REPAIR DOCUMENT

Ag Hopper Trailer – Hopper Side Slope Panel to Lower Rail Connection – Recall Remedy

Repair Document #: **RD-00056**

US NHTSA Recall No. 16V050

Condition #1 - Desired Result

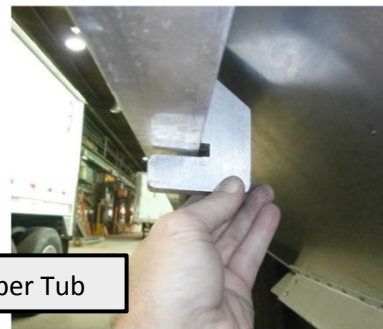
Above figure shows the template up tight against the bottom of the lower rail prior to hitting the hopper tub.

Condition #2 - Un-Desired Result

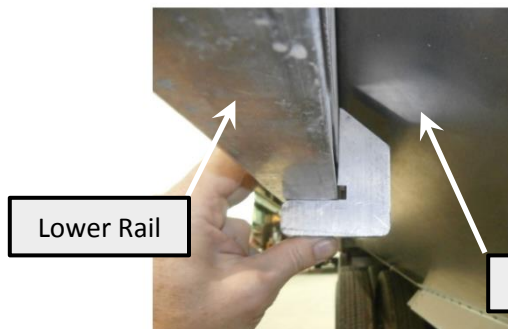
Above figure shows the template up against the bottom of the hopper tub prior to hitting the bottom of the lower rail.

Any trailer that fits condition #2 of the Hopper Side Slope Panel to Lower Rail fit inspection must have additional fasteners added per the procedure described below.

1. If the hopper tub has been found to be in the undesired position after inspection (Condition #2), then it is necessary to add some fasteners to insure the integrity of the hopper tub connection.
 - a. Fasteners are to be added along the lower rail of the trailer.

Condition #3

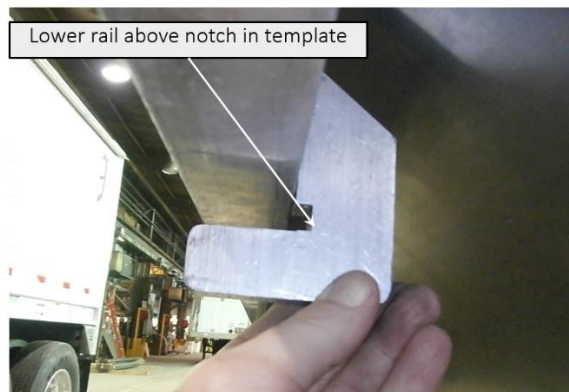
Above figure shows the template up against the bottom of the hopper tub and the lower rail above the notch in the template. If this condition is found, PLEASE CONTACT STOUGHTON TRAILERS CUSTOMER SERVICE for further instructions.

If condition #3 is found on any trailer during the Hopper Side Slope Panel to Lower Rail fit inspection, please contact Stoughton Trailers Customer Service for further instructions

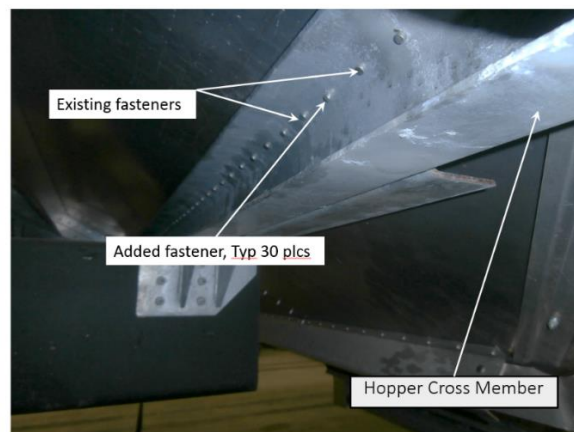
Add fasteners between each fastener along the hopper cross members, (30) ¼ Solid Rivets

- b. Fasteners will also be added along the front and rear cross members supporting the tub.
